Diagnostic Sheet

MC20 – Side Door Anomalies

DATE: MAY 30, 2025

MODELS: M240 MC20 and MC20 Cielo (All MY).

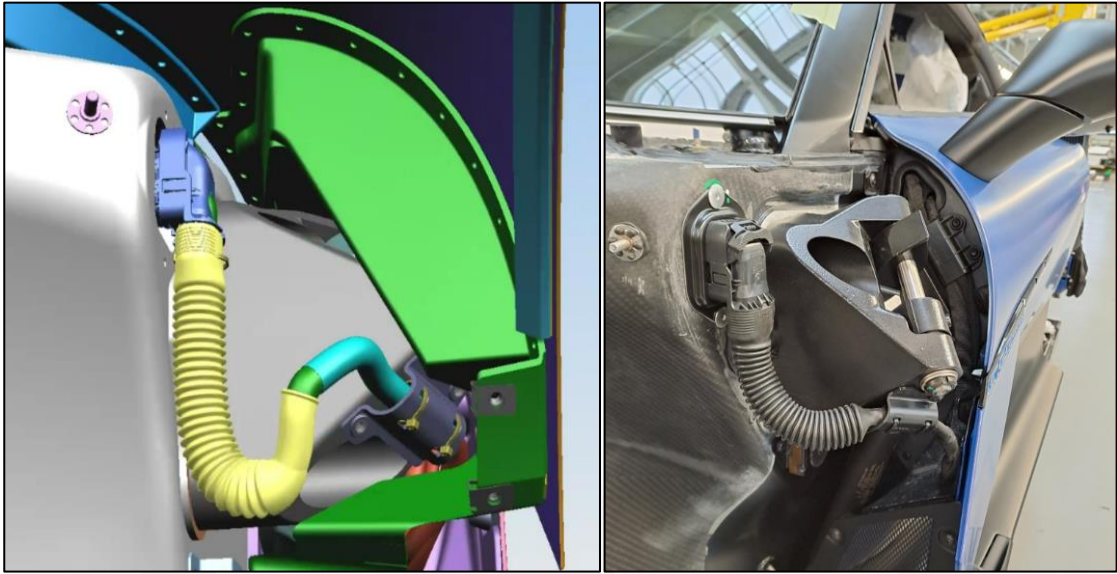
In case of oxidation as shown in the photo below:

Door side: Replace the door wiring harness with the corresponding P/N of the GT2S version, which has a slightly revised shape. It is recommended to replace both wiring harnesses, right and left.

RIGHT DOOR		LEFT DOOR	
ERA	BECOMES	ERA	BECOMES
670215792	670353382	670215790	670353378
670215793	670353383	670215791	670353379
670215422	670353384	670215421	670353380
670175236	670353385	670175235	670353381

Old Layout

New Layout

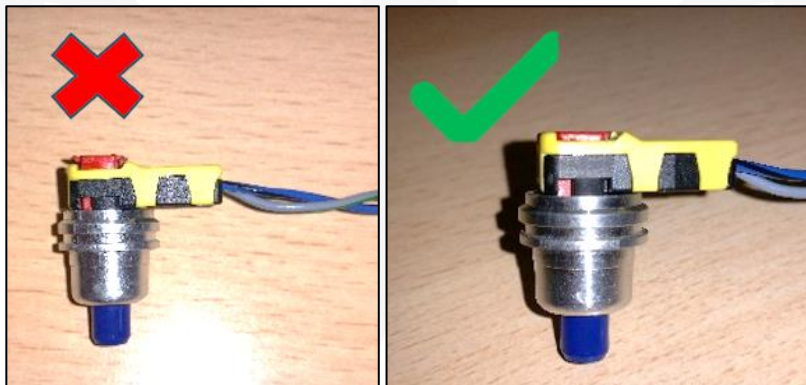
- 1) Save an ORC ECU parameter and DTC report.
- 2) Remove the door panel and inspect only visually and without disconnecting the electrical connections of the airbag module and the door panel bridle and the related wiring. Take photos of the related connections and of any anomalies found on the wiring.

NOTE: when removing the door panel, pay close attention to gently release the plastic clip retaining the connection shown in the image below on the right.

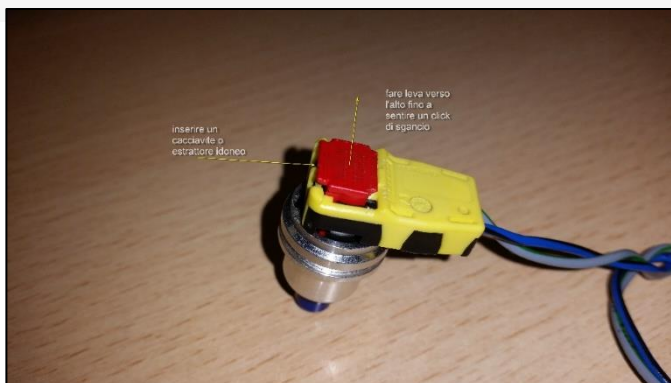
With the battery disconnected, check the condition of the connector on the pyrotechnic charge on the curtain airbags; the red safety clip MUST be in the FULLY inserted position (see photo below).

In case of incorrectly entered CPA, proceed as follows:

- Gently insert a flat screwdriver into the CPA coupling cavity, lever upwards until the CPA disengages.
- Pull the connector out perpendicularly.

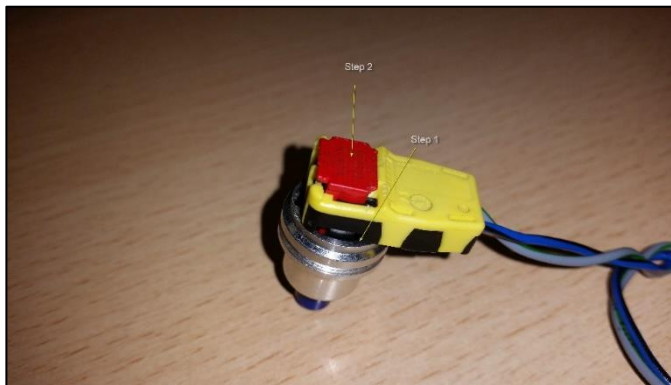
- Step 1: Insert the connector into the pyrotechnic charge seat WITHOUT pressing the red CPA.
- Step 2: Once the connector is inserted, press the red CPA down until it stops.
